SERVICE INFORMATION LETTER NO. T-027

Revision 4

1. SUBJECT: Tail Rotor P/C Link Installation Inspection

2. MODEL: 480 and 480B

Figure 1. Tail Rotor Rotating Controls

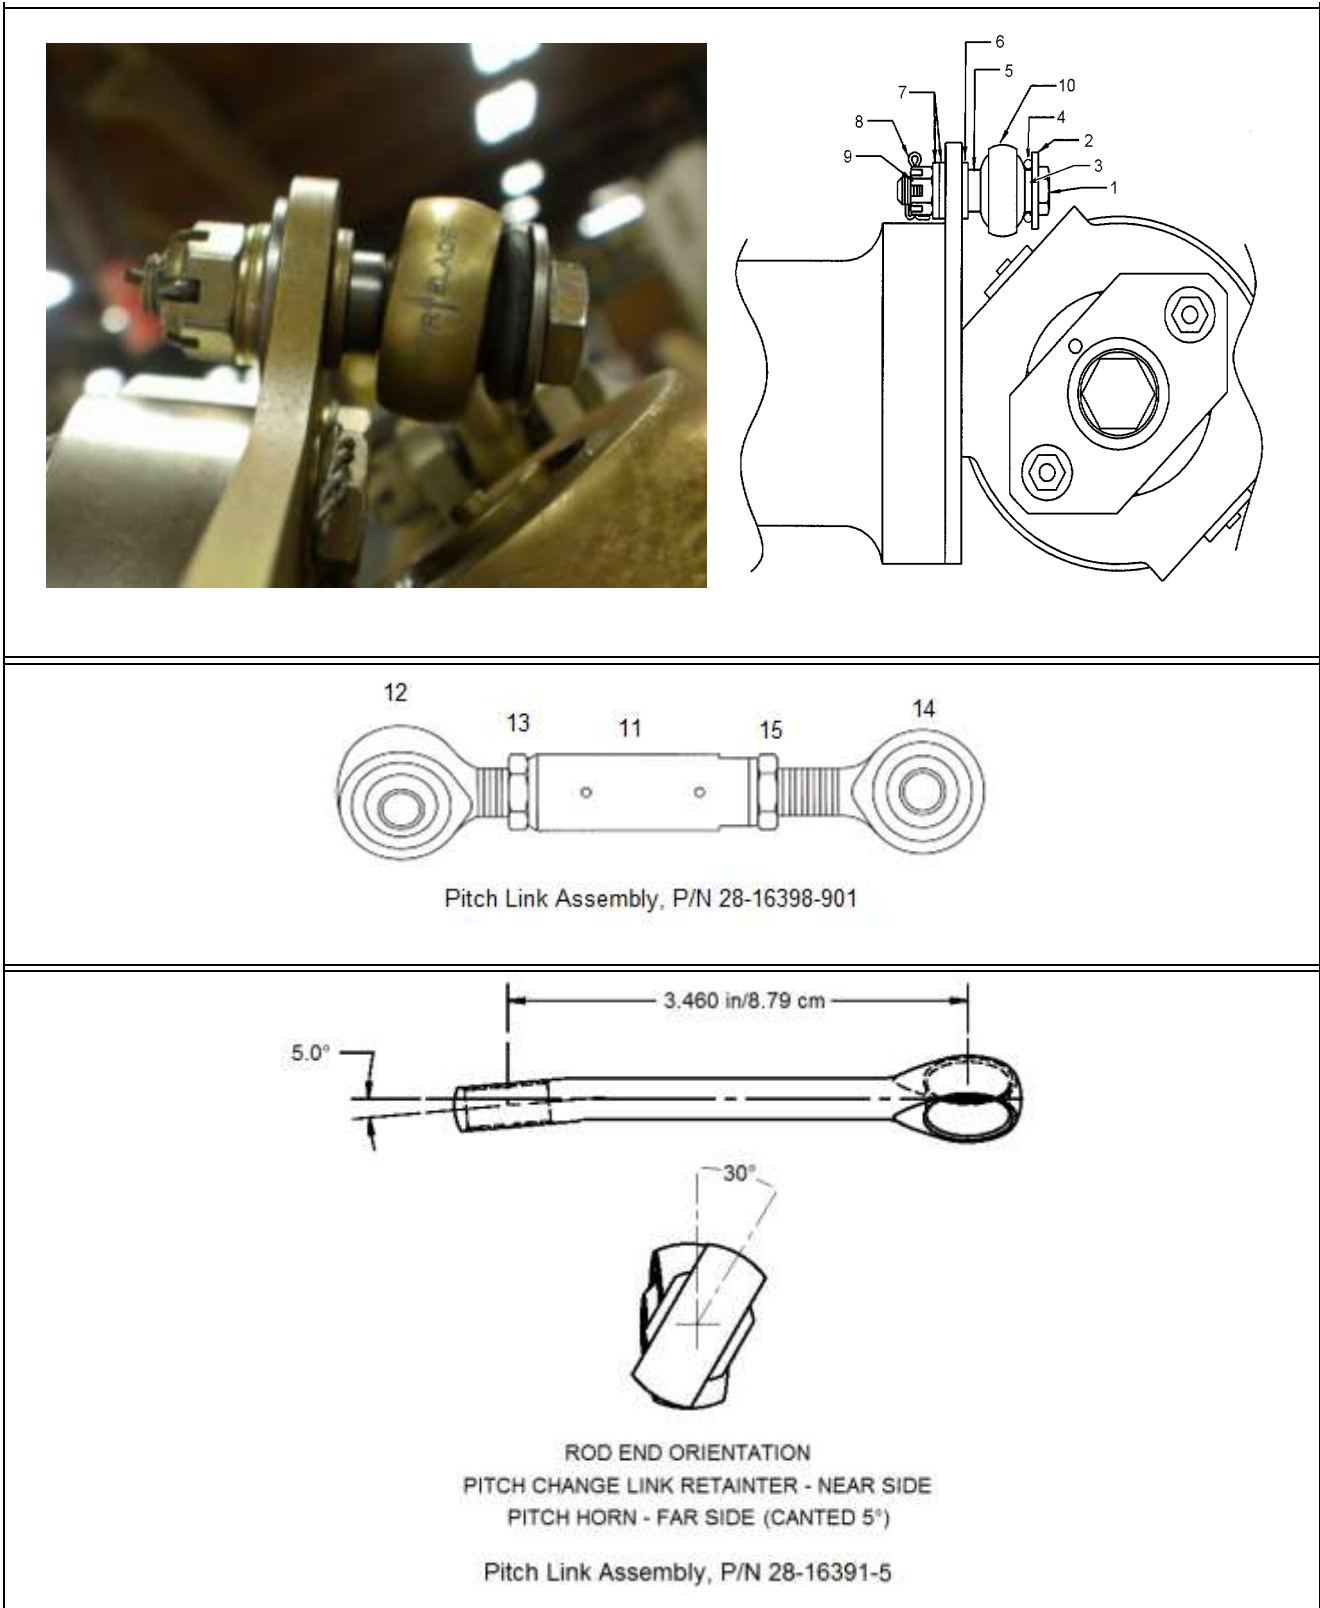
Revision 4 replaces AN960-416 washers (cad plated carbon steel) with NAS1149C0463R washers (passivated stainless steel). (Revision 4 supersedes SIL T-027 Revision 3.)

Revision 4 incorporates information on required washer replacement.

5.1.1 Inspect both tail rotor pitch link change installations for proper and secure installation hardware in accordance with Figure 1.

- 5.1.8 Connect the pitch change link (10) to the pitch arm with the hardware in the following sequence: bolt (1) (bolt head installed in the direction of rotation), Harper washer (2), thin spacer (3), O-ring (4), pitch change link rod end (10), thick spacer (5), washer (6), pitch arm, washer(s) (7), and nut (9). Torque the nuts (55-75 in-lbs/6.2-8.5 Nm) and install new cotter pin (8).

5.2.1 Remove and install the tail rotor pitch change link assemblies in accordance with the applicable maintenance instructions for each model aircraft and in accordance with step 5.1.8 above. **NOTE:** The P/N 28-16391-5 (and P/N 28-16391-3) tail rotor pitch link assembly has the label “T/R↑BLADE” etched on the rod end that is canted 5°. This end must attach to the tail rotor and the arrow must point toward the tail rotor blade (see photo in Figure 1).

* Use as required for dynamically balancing the tail rotor. Each AN960 washer is to be replaced with its equivalent size NAS1149C04XXR washer.

** Install each pitch change link assembly with the rod end labeled T/R↑BLADE on the tail rotor pitch horn side with arrow pointing toward the tail rotor blade.
